UNITED STATES PATENT AND TRADEMARK OFFICE

APPLICATION NO.	FILING DATE	FIRST NAMED INVENTOR	ATTORNEY DOCKET NO.	CONFIRMATION NO.
10/805,787	03/22/2004	Montgomery W. Childs	MBT-13302/03	9947
25006	7590	11/30/2005	EXAMINER	
GIFFORD, KRASS, GROH, SPRINKLE & CITKOWSKI, P.C			DEUBLE, MARK A	
PO BOX 7021			ART UNIT	
TROY, MI 48007-7021			PAPER NUMBER

Office Action Summary	Application No. 10/805,787	Applicant(s) CHILDS, MONTGOMERY W.	
	Examiner Mark A. Deuble	Art Unit 3651

DETAILED ACTION

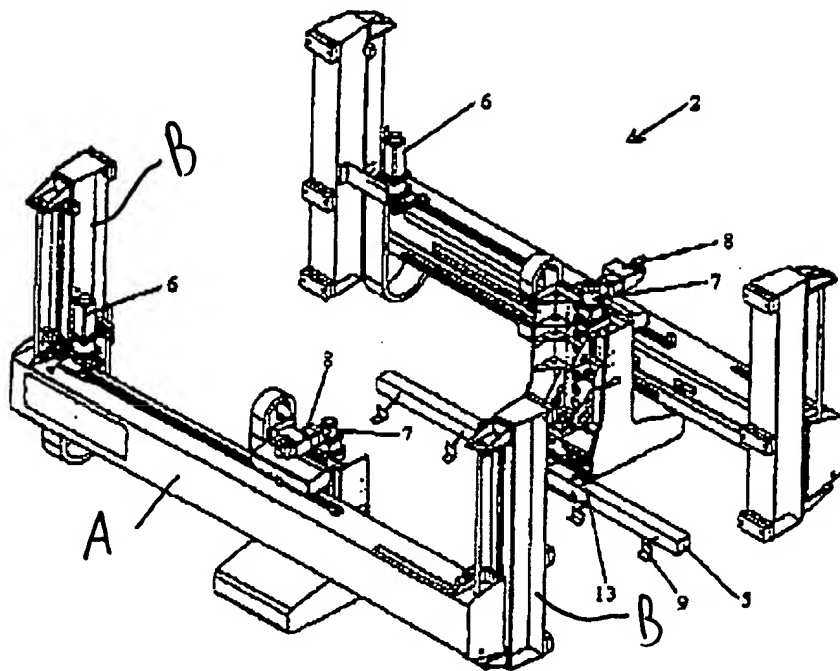
6. Claim 11 is rejected under 35 U.S.C. 102(e) as being anticipated by Childs et al. (U.S. patent No. 6,910,362).

Childe et al. shows a transfer system for transferring workpieces between successive die stations in a stamping press 1 having left, right, front, and back sides. The transfer system includes a horizontal support beam A adapted for placement adjacent one of the sides of the press, a supporting structure B which supports the beam, and a mounting head 13 mounted on the support beam for horizontal movement along the support beam (see Fig. 4 reproduced below).

Each mounting head includes a coupling 18 at the distal end thereof which mounts an elongate bar 5 with a series of workpiece holders 9 thereon to the mounting head. The mounting head includes a vertical transport mechanism 8 which moves the mounting head and the coupling vertically. A longitudinal transport drive 6 is coupled to the mounting head to move the mounting head in a left-right direction relative to the press. Thus Childs et al. shows all the structure required by claim 11.
